ORIGINATION FORM

Proposed Revisions to a Standard Plans Index

Index Number: 715-010

Index Title: HIGH MAST LIGHTING

LAST REVISION 11/01/18	REVISION	DESCRIPTION:		FY 2023-24 STANDARD PLANS	HIGH MAST LIGHTING	INDEX 715-010	SHEET 1 of 6
--------------------------------------	----------	--------------	--	------------------------------	--------------------	------------------	-----------------

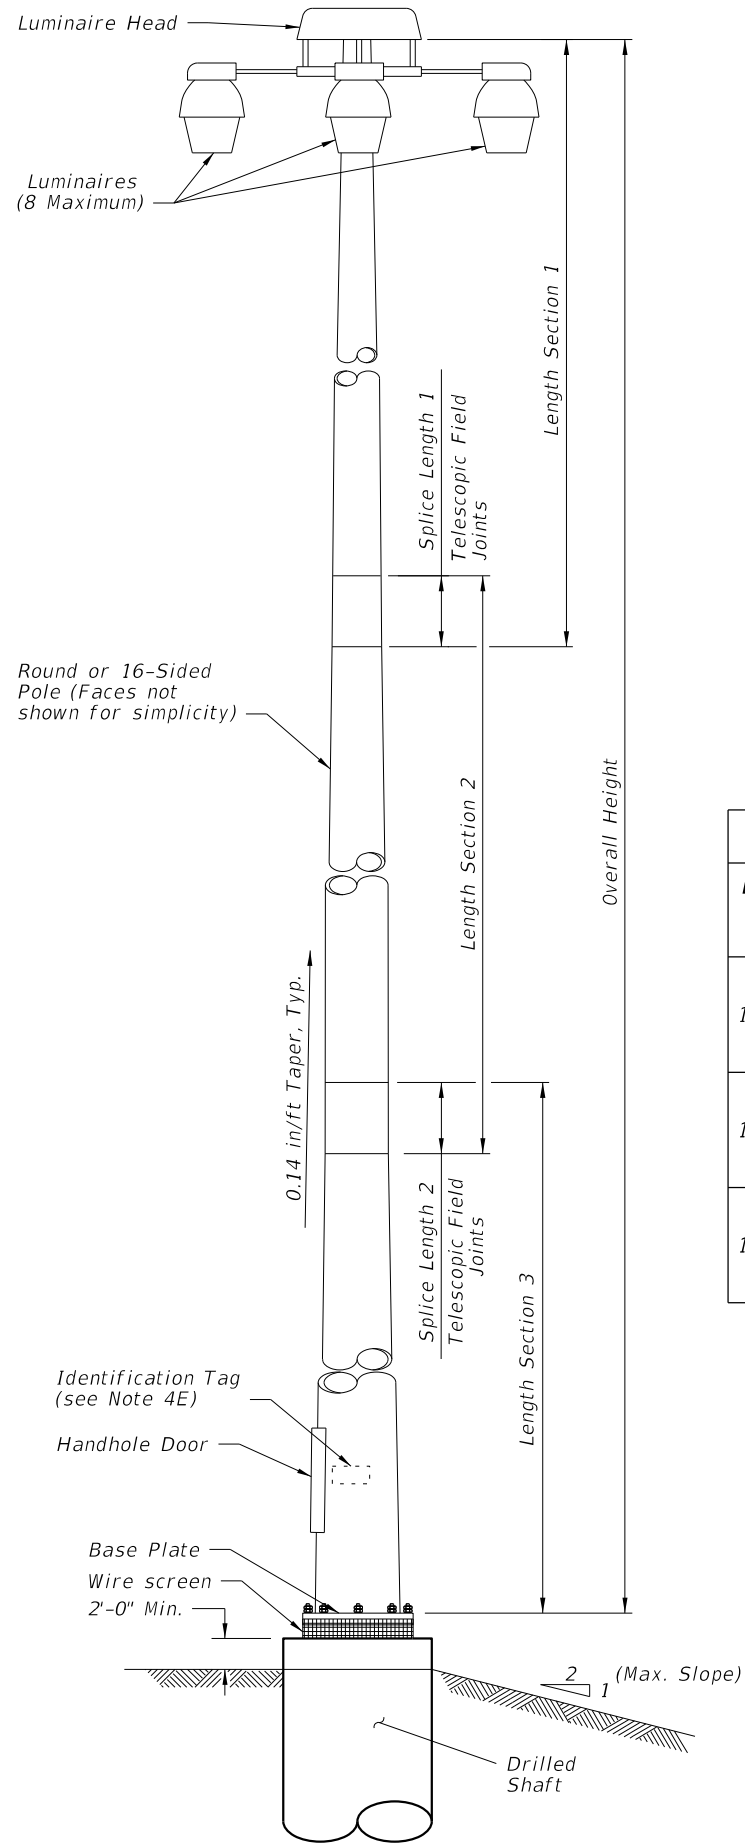
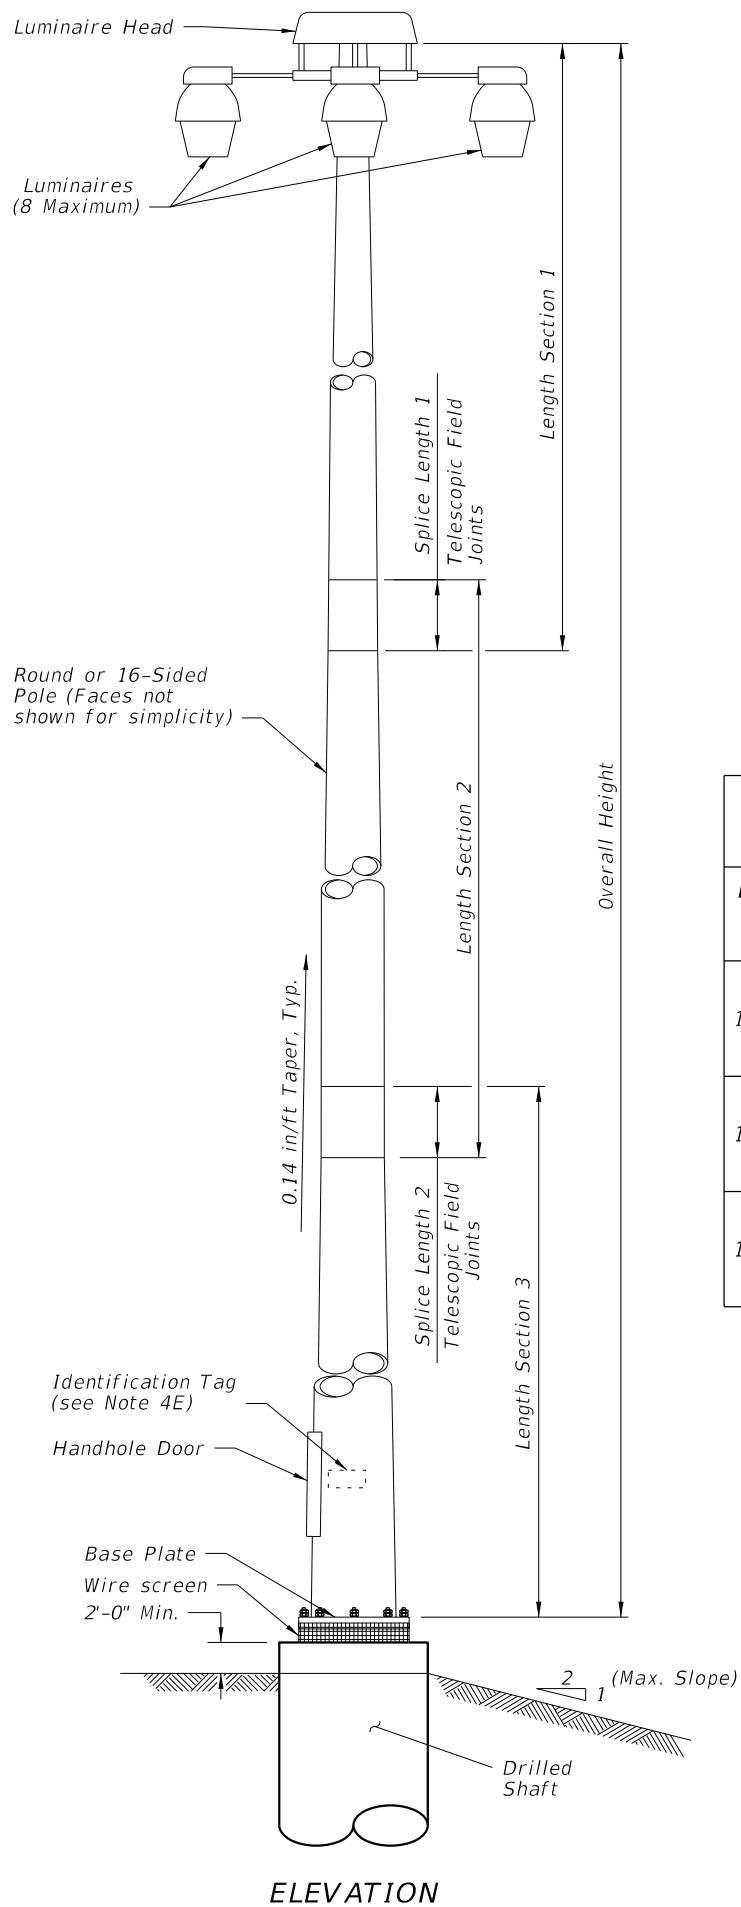
Sheet 1: Changed phrase from "full-penetration groove" to "complete joint penetration".

Sheet 1: Changing non-standard language to standard language consistent with AWS.

complete joint penetration

- i. Use a complete joint penetration weld within 6 inches of the circumferential tube-to-plate connection and
 - ii. Use complete joint penetration welds on the female end section of telescopic (i.e., slip type) field splices for a minimum length of 42 inches.

POLE DESIGN TABLES

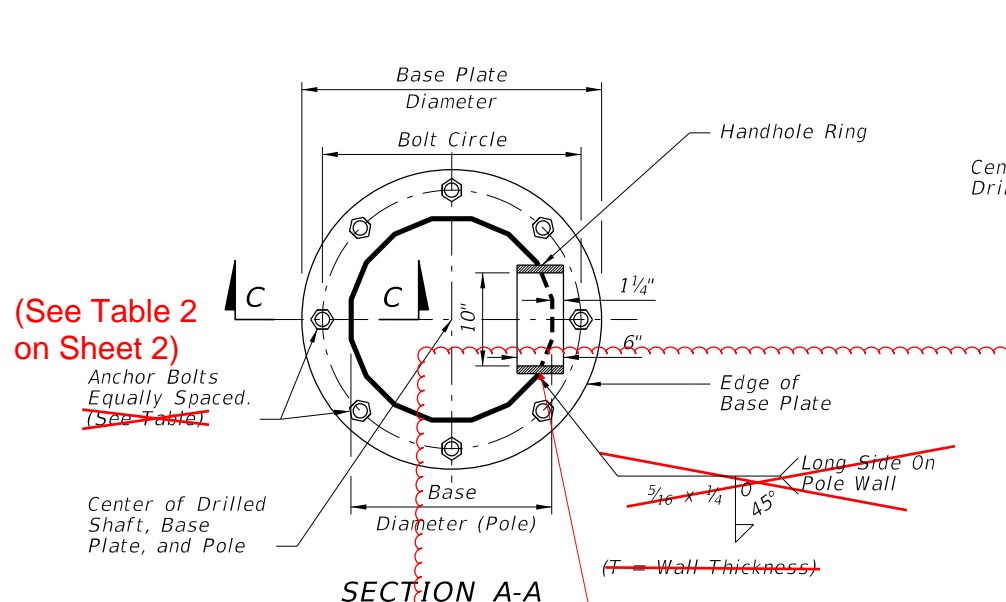
Sheet 2: Added Table numbers for reference.

**TABLE 1
POLE DESIGN TABLE***

**TABLE 2
BASE PLATE AND BOLTS DESIGN TABLE**

**TABLE 3
SHAFT DESIGN TABLE**

**TABLE 4
ADDITIONAL SHAFT DEPTH DUE TO GROUND SLOPE**

SECTION A-A

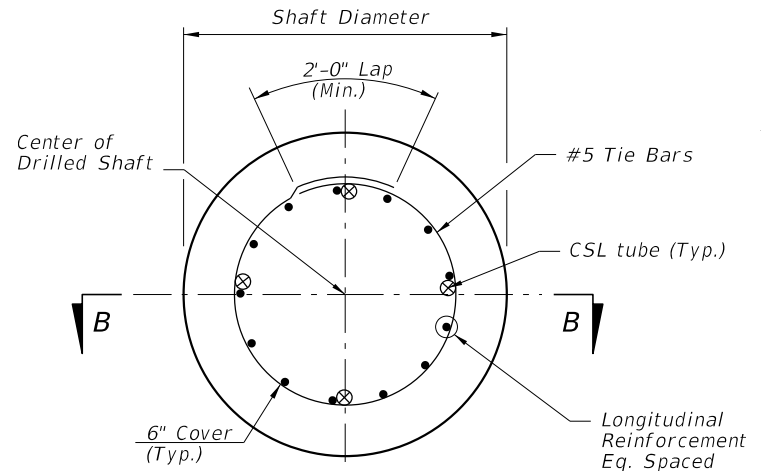
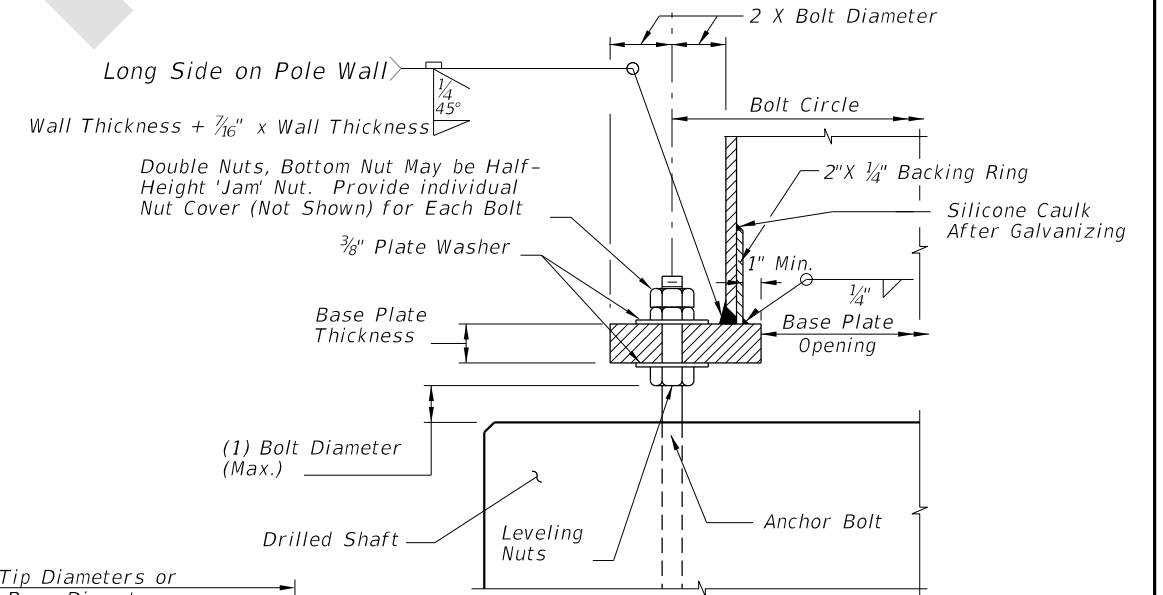
Sheet 3: Corrected the welding arrows on Section A-A and C-C to be consistent with AWS; Added note to Section CC that silicone caulk should be done after galvanizing; Changed weld detail to say "CJP."

Sheet 3: During a review of a fabricators QC Plan it was found that the Standards welding symbols were not formatted correctly. We corrected this to be consistent with AWS; Changed non-standard language about penetration welds to standard language consistent with AWS.
